RE: Repair Designs for the Lower Section of Reclamation Channel SD-6,  
Gordon Creek 2, 7, and 8 Mines, Permit # C/007/0016

Title: Reclamation Channel SD-6 Repair

#### Revised Plan for Repair of Reclamation Channel SD-6 at the Gordon Creek 2, 7, 8 Mines, Carbon County, Utah

FIGURE 1. REPAIRED RECLAMATION CHANNEL SD-6 CROSS SECTION

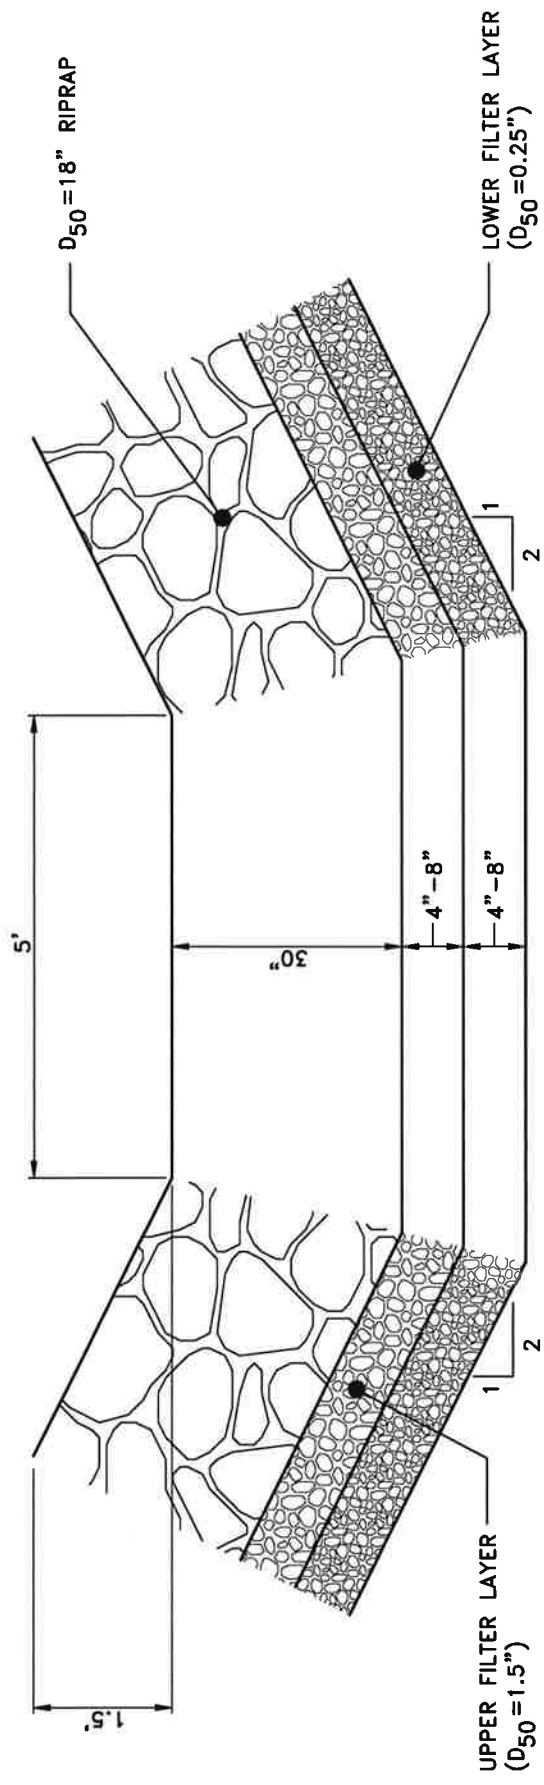
Consistent with the recommendations of Brown and Clyde (1989), each filter layer will be placed to a thickness of 4 to 8 inches. The resulting cross section of the lower portion of reclamation channel SD-6 is shown in Figure 1.

Only the lower of channel SD-6 will require repair. In accordance with the above calculations, the channel will be replaced as indicated on Figure 1. The basic plan for repair of the channel is as follows:

- Mobilize equipment and materials to the site and install sediment controls as necessary.
- Recover riprap and filter material that has accumulated at the downstream end of the channel for re-use as appropriate.
- Regrade the lower section of the damaged channel, as necessary, to fill eroded sections and achieve the required grades.
- Install the lower filter bedding ( $D_{50}=0.25$  inch) to a depth of 4 to 8 inches.
- Install the lower filter bedding ( $D_{50}=1.5$  inches) to a depth of 4 to 8 inches.
- Install  $D_{50} = 18$  inch riprap to a depth of 30 inches.
- Revegetate all areas disturbed by this project.
